NEW YORK STATE DEPARTMENT OF ENVIRONMENTAL CONSERVATION
DIVISION OF HAZARDOUS WASTE REMEDIATION
INSPECTOR'S DAILY REPORT

Site Code No. <u>344004</u>	Date <u>6-4-01</u>	I.R. No. <u>13</u>	
Site Name: <u>Ramapo L.F.</u>	Sheet <u>1</u> of <u>2</u>	AM	PM
Location: <u>Ramapo NY</u>	Weather	<u>clr</u>	<u>clr</u>
Engineer: <u>URS</u>	Temperature	<u>55</u>	<u>65</u>
Contractor: <u>PT+L</u>	Wind (Dir./Vel.)	<u>0</u>	<u>0</u>
Job Phone: <u>()</u>	10-12

DRAWING SHOWING CHANGES AT CHANNEL #1

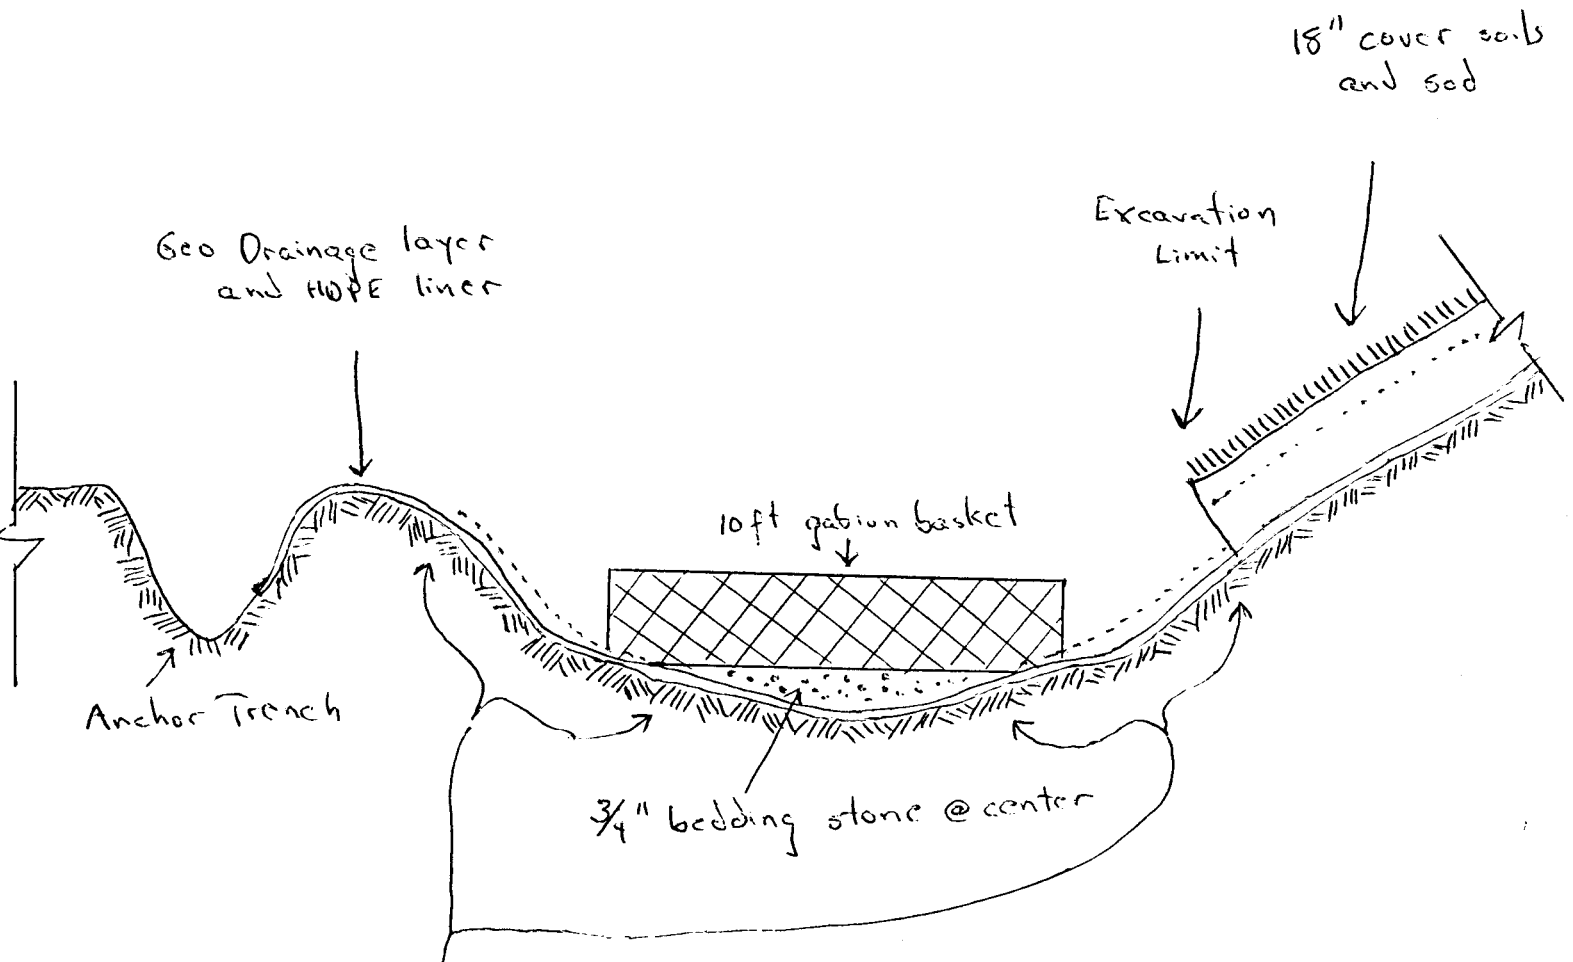
① Substitution of fabric for 12" $\frac{3}{4}$ " stone bedding under gabion baskets without approval② Contractor stated that during access road installation several areas found where total cover over liner is only $\approx 6"$. (Plans call for 18")

- (a) Completed first 300' of excavation, liner repairs and geo-drain repairs. Liner repairs checked with vacuum box.
- (b) Placed 3/4" bedding stone at center of first 100' of channel
- (c) Placed 16 oz fabric as substitute for 1ft bedding stone on sides of channel. Note: This is not in accordance with approved plans and specifications. Advised engineer that they are proceeding at their own risk.
- (d) Began placing geosion baskets and began hand placing stone inside of them.

- (c.) See drawing regarding bedding sheet 3 of 3.

→ ① Installation of gabion baskets without 1ft bedding material shown on approved drawings. One layer of 16 oz fabric has been substituted. May result in damage to liner at channel #1.

Areas where fabric substituted for 12\" 3/4 stone bedding

(Gabion basket "wings" to be installed)
in these areas too
